Access Compliance Report

Public Rights-of-Way

Intersection ID: 28730	Main Street: AVENTIDE_LN	Cross Street: BANYAN_CT	Location: NE
ADA ID: A22B4D42E7B0	Ramp Type: Perp	Initial Pass/Fail: Fail	Overall Compliance: No
		Severity Score: 25

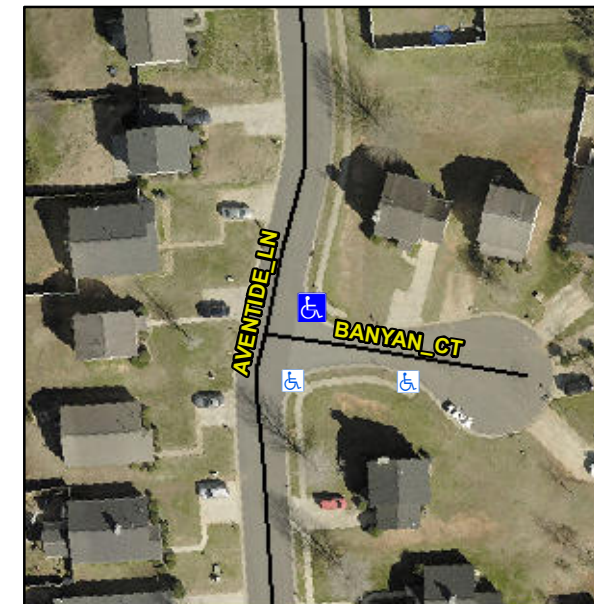
Not Found, R304.5.3

Compliance	Description	Data	Compliance	Description	Data
N/A	Ramp Length (in)	46.0	Yes	Ramp Slope (%)	6.0
Yes	Ramp Width (in)	48.0	No	Ramp XSlope (%)	15.0
N/A	Flare Type LT	N/A	N/A	Flare Type RT	N/A
N/A	Flare Slope LT (%)	N/A	N/A	Flare Slope RT (%)	N/A
N/A	Flare Traversable LT?	N/A	N/A	Flare Traversable RT?	N/A
N/A	Landing Length (in)	N/A	N/A	DWS Provided?	N/A
N/A	Landing Width (in)	N/A	N/A	DWS Contrast?	N/A
N/A	Landing Slope (%)	N/A	N/A	DWS Length (in)	N/A
N/A	Landing X Slope (%)	N/A	N/A	DWS Full Width?	N/A
N/A	Landing Curb? (Y/N)	N/A	N/A	DWS Offset (in)	N/A
N/A	Shared Landing?	N/A			
N/A	Gutter Ponding?	N/A	N/A	Gutter Slope (%)	N/A
N/A	Gutter Lip Ht (in)	0.5	N/A	Gutter X Slope (%)	N/A
N/A	Painted X Walk1?	No	N/A	Painted X Walk2?	N/A
	X Walk 1 Direction	To S		X Walk 2 Direction	N/A
N/A	X Walk 1 Width (in)	N/A	N/A	X Walk 2 Width (in)	N/A
	X Walk 1 Slope (%)	5.1		X Walk 2 Slope (%)	N/A
	X Walk 1 X Slope (%)	10.5		X Walk 2 X Slope (%)	N/A

Remove & Replace Entire Ramp.
